Addendum #2

VA Project No.: 553-21-100

Project: Renovate A2 South for Cancer Clinic
John D. Dingell VA Medical Center
Detroit, Michigan

Date: May 1, 2026

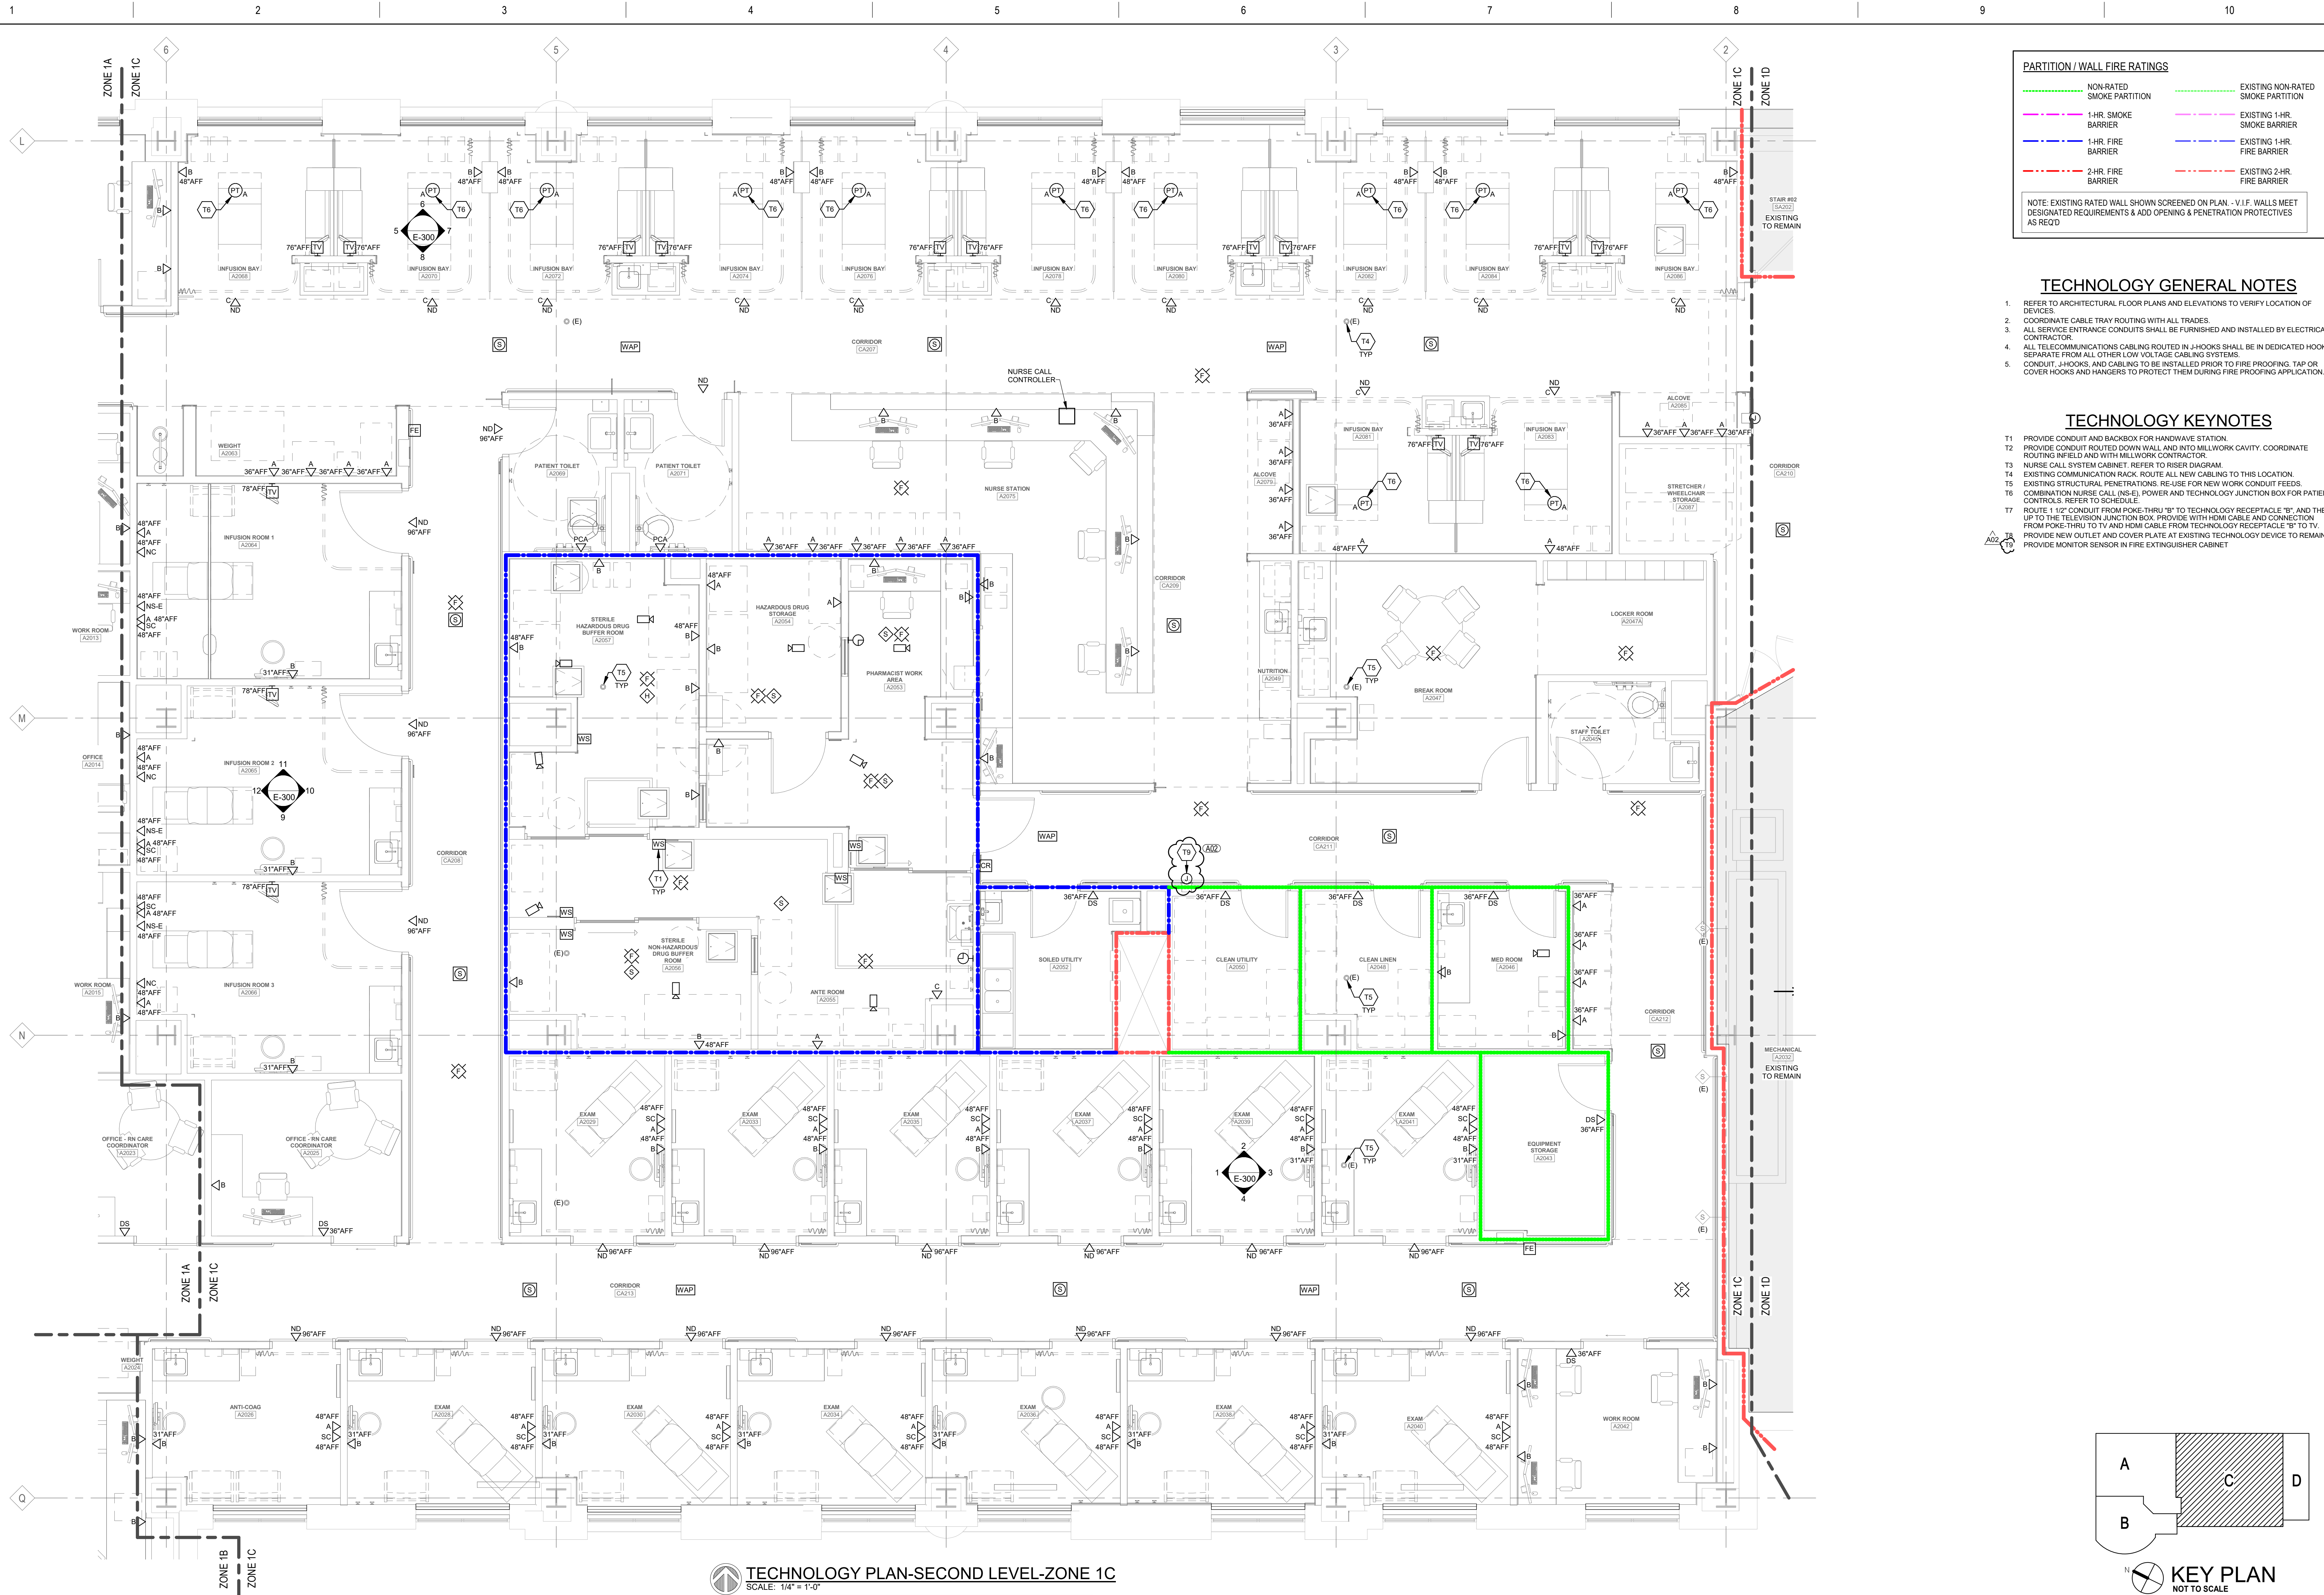
- A2.21 Refer to Sheets ET102.1B, ET102.1C, and ET102.1D (reissued):
Provide fire extinguisher cabinet monitor at locations indicated on plan and call out with new keyed note T9.
